**FINDINGS AND RECOMMENDATION
OFFICE OF PLANNING AND ZONING
ANNE ARUNDEL COUNTY, MARYLAND**

CASE NUMBER: 2023-0212-V

The applicants are requesting a variance to allow a dwelling addition (garage) with less setbacks than required on property located at 1000 Mount Airy Road in Davidsonville.

ORIGINAL SITE PLAN

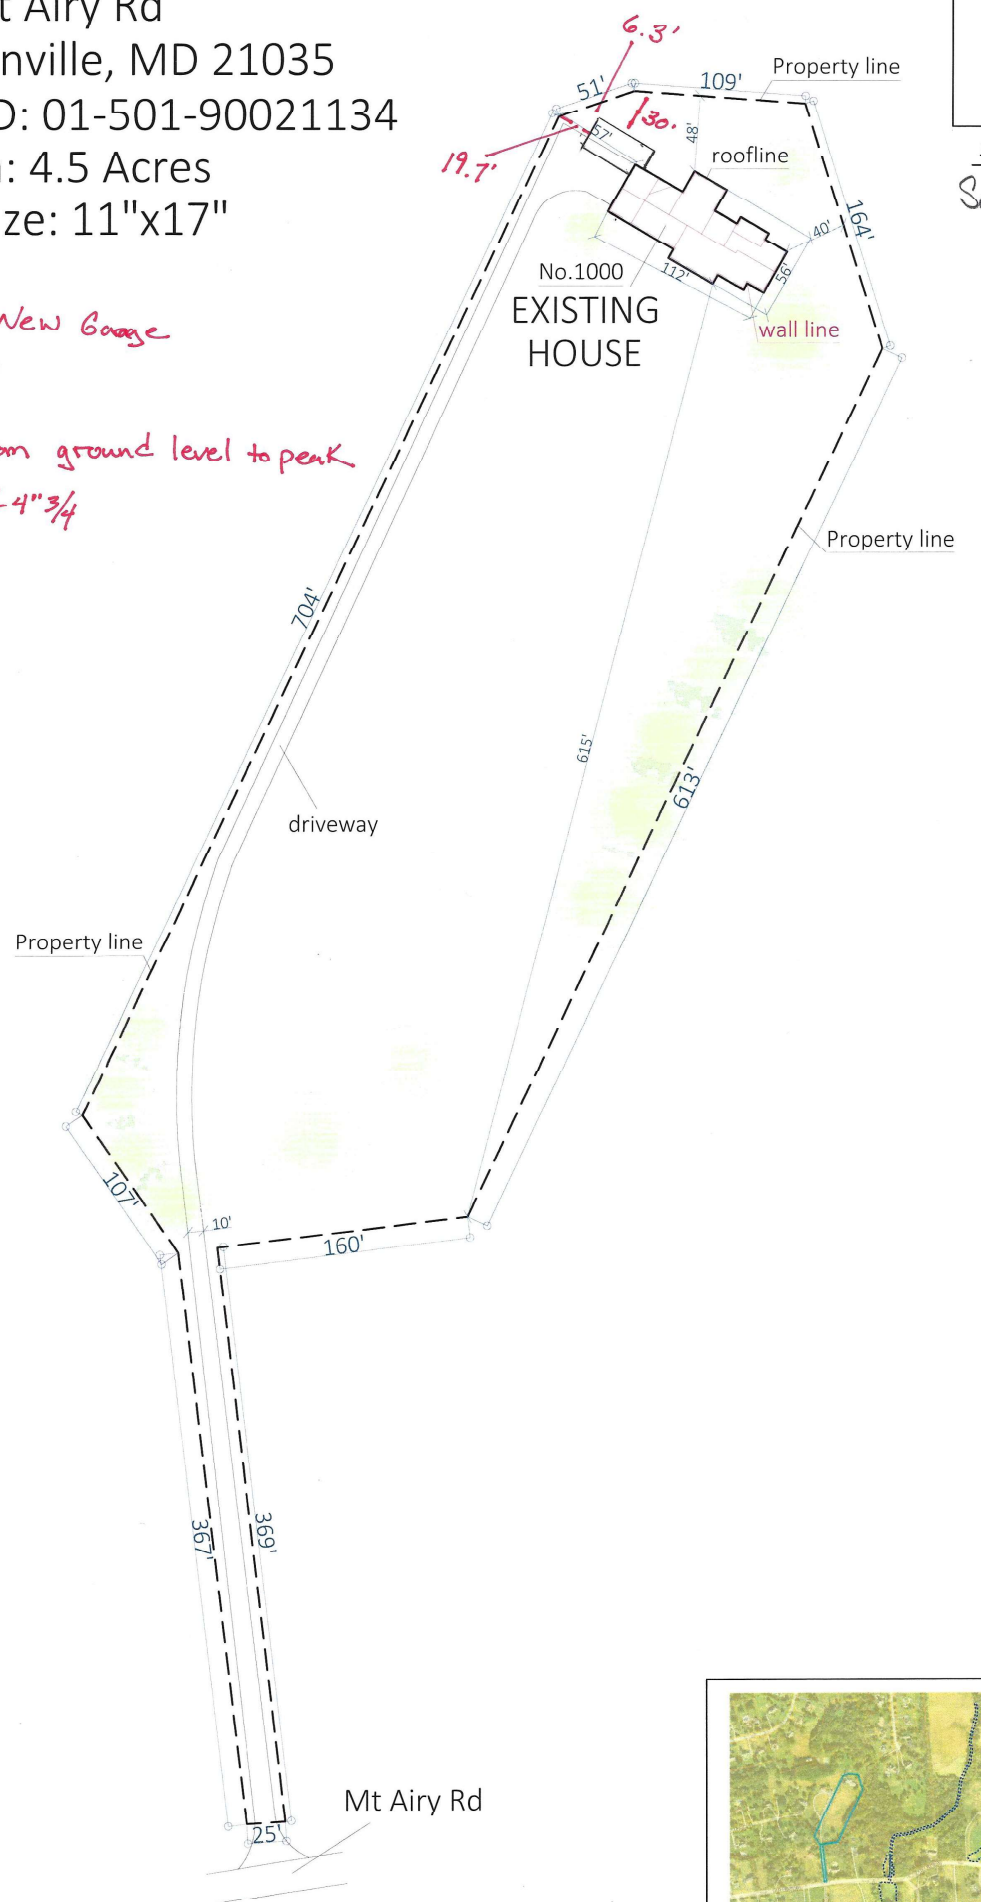
§ 18-4-301 of the Anne Arundel County Zoning Ordinance provides that a principal structure in an RA District shall be set back a minimum of 35 feet from the rear lot line. At its closest point, the proposed dwelling addition (attached garage) would be located 6.3 feet from the rear lot line, necessitating a variance of 29 feet.

The **Health Department** has determined that the minimum separation required between the proposed building addition and the proposed well have not been met. A minimum separation of thirty (30) feet must be provided to protect the individual well water supply system from a foundation or soil treated to control pests, insects, or vermin. Therefore, the Department recommends denial of the variance request. The applicant must show the water well and septic system location on the site plan. An Administrative variance with the Health Department may be granted to have the structure 20 feet from the up-to-code water well.

In the case of the subject property, while the irregular lot shape and the existing dwelling location in the far rear are somewhat unique, those conditions are not causing the need for a variance nor are they preventing the applicants from developing the lot in conformance with the Code. The applicants' letter of explanation merely describes the proposal, but it does not provide any justification to demonstrate practical difficulties or unnecessary hardship. Based on the County birdseye aerial imagery, the applicants already enjoy the benefit of an existing three-car garage (measuring approximately 30-feet in length) on the northwest side of the house. The garage loads from the side via two garage doors, one single and one double, which can be seen in the open position on recent aerial photographs. In addition to the fact that the property already contains a larger than typical attached garage, there also appears to be room for the proposed garage addition on the south side of the existing garage, without requiring a setback variance. Similarly, the proposed garage could be rotated 90 degrees and attached to the western side of the existing garage, significantly minimizing, if not eliminating, the setback variance.

Approval of the proposed variance would not necessarily alter the essential character of the neighborhood, impair the appropriate use or development of adjacent property, or be detrimental to the public welfare. However, given that the property already has the benefit of a three-car garage and the fact that other development options appear to exist that would allow for a substantial attached garage addition without the requested setback relief, the variance is not warranted and cannot be considered the minimum necessary to afford relief.

Based upon the standards set forth in § 18-16-305 of the Code under which a variance may be granted, this Office recommends ***denial*** of the requested variance to § 18-4-301. Should the Administrative Hearing Officer determine that variance relief is warranted, any approval must be conditioned on satisfying the Health Department's variance comments (relating to the minimum required separation between the proposed structure and the well) at the time of permitting.

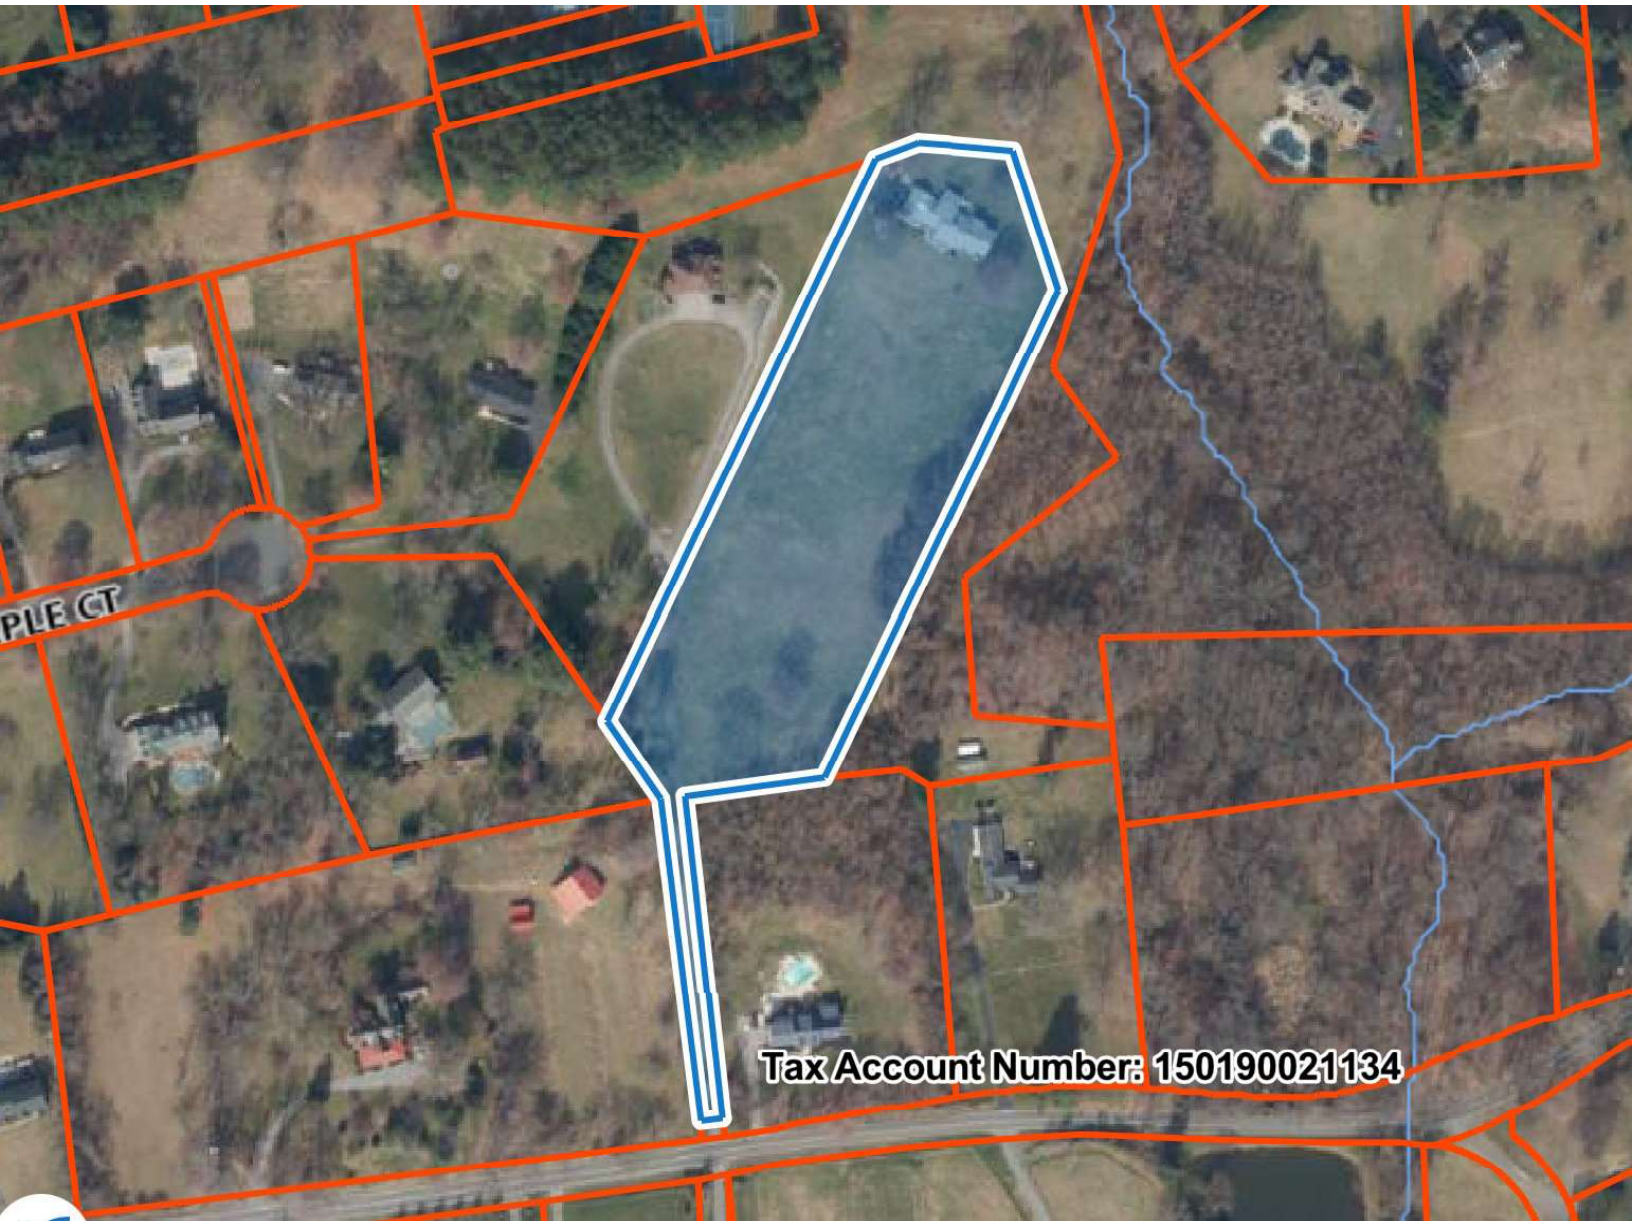
The Health Department has determined that the minimum separation required between the proposed building addition and the proposed well have not been met. A minimum separation of thirty (30) feet must be provided to protect the individual well water supply system from a foundation or soil treated to control pests, insects or vermin. The Health Department recommends denial of the above referenced request. Show the water well and septic system location on the site plan. An Administrative variance with the Health Department may be granted to have the structure 20 feet from the up to code water well.
